Submission by **Sustainable Northern Beaches** (a committee within Climate Action Northern Beaches Inc.)

To a Planning Proposal for Wilga-Wilson precinct

Lodged with Northern Beaches Council in September 2025 by Mirvac, Tusland and others.

3D CONCEPT MODEL (SUPPLIED) WITH PROPOSED BUILDING HEIGHTS HIGHLIGHTED:
RED - 24m; YELLOW - 11m.

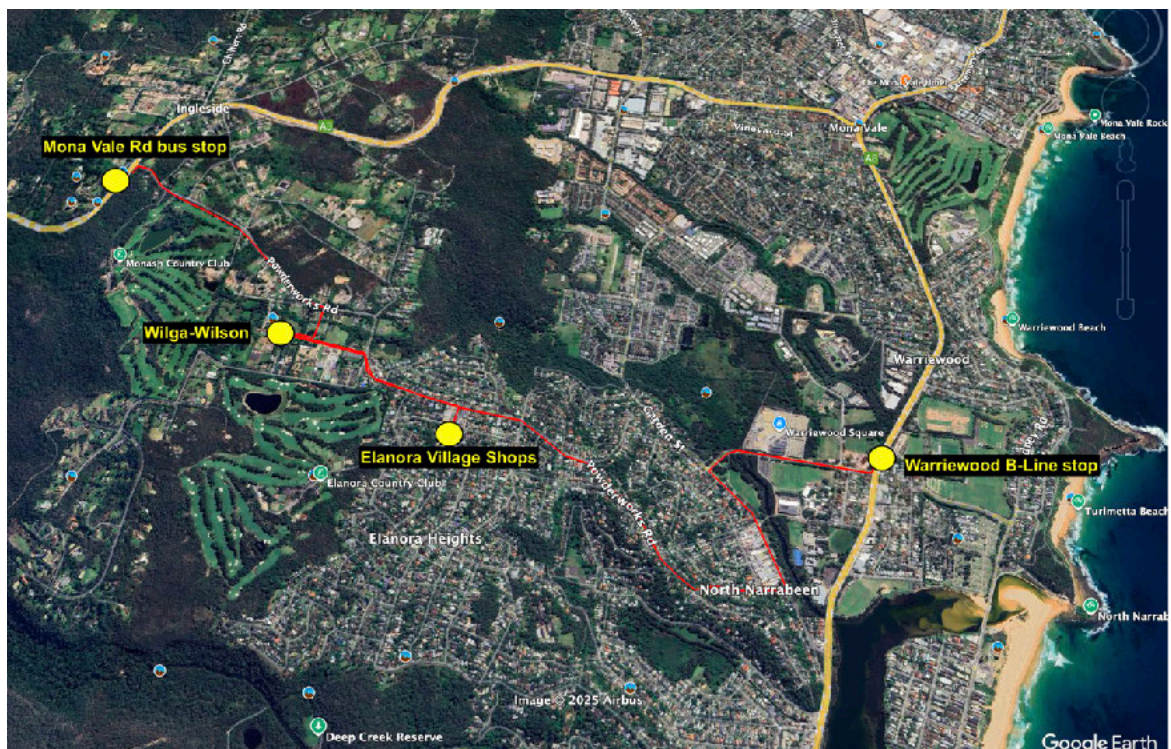
5. **Height of buildings** – The Proposal includes a Height of Buildings map (paragraph 6.3 on p.31-32 of Planning Report), that shows areas of 11m and 24m building height within the proposed R3 zone, and following on from that a changed Floor Space Ratio (para 6.4 on p.32-33 and other referenced pages).

- 5.1. **The Desired Future Character' statement** contained in the current PLEP 2014 (discussed above) states for both Ingleside and Elanora Heights that building should give the **appearance of 2 storeys**. These character statements were crafted after long and very effective community consultation, and have been accepted by the local community.

To so dramatically change that desired future character requires at least the same process of broad community consultation, without which **Council has no mandate** to make such change. The very limited consultation in area notified and time available to respond **does not qualify as equivalent consultation**.

- 5.2. **Affordable housing provisions currently contain a loophole that would allow an extra two storeys – to 8 storeys-** to be applied for and approved after initial Planning or Development Consent is granted. This anomaly in the otherwise well intentioned legislation makes a mockery of height limits that might be otherwise agreed.

It must therefore be assumed that this loophole will be pursued, and is one more reason to limit overall building heights to 8.5m as per the current DCP.

PREFERRED WHOLE OF SOUTH INGLESIDE LAND USE MAP
SHOWING WILGA-WILSON AS AN ECO-VILLAGE
[© ENVIROTECTURE]

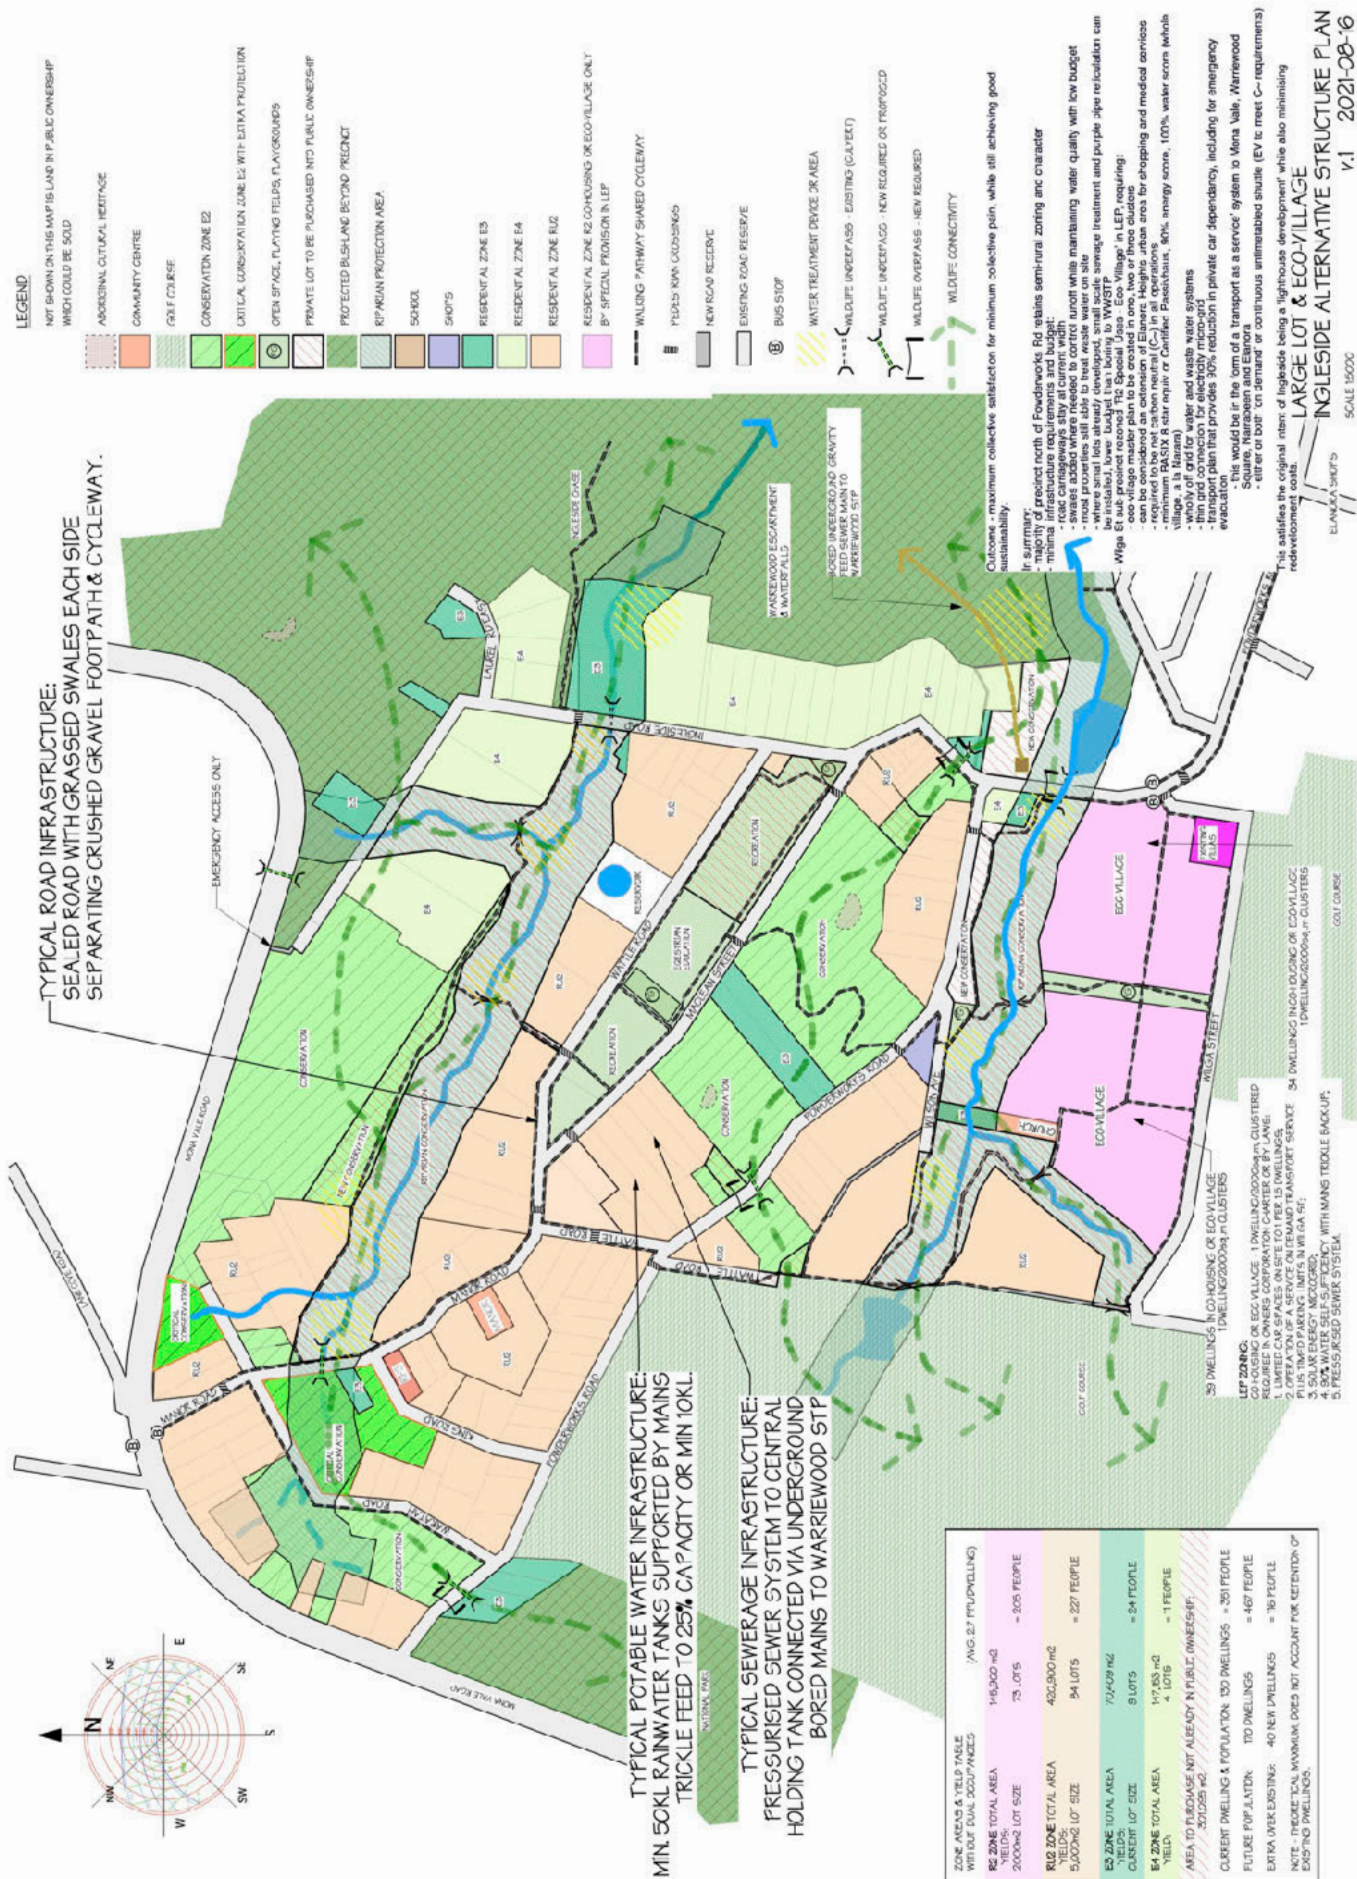
17. **Preferred development model: eco-village as part of masterplanned suburb**

We refer to our 2021 submission of alternative masterplan for the whole of south Ingleside, where Wilga-Wilson is a low-scale medium density eco-village. This would provide the opportunity to be carbon neutral for electricity, gas free, with recycled water for landscapes etc, and proper riparian zone regeneration.

It is possible to increase the density compared to that shown on the mapping below, without using multi-storey buildings.

Importantly, it would be ‘at scale’ and compliant with the current desired future character statements in both Ingleside and Elanora Heights DCPs.
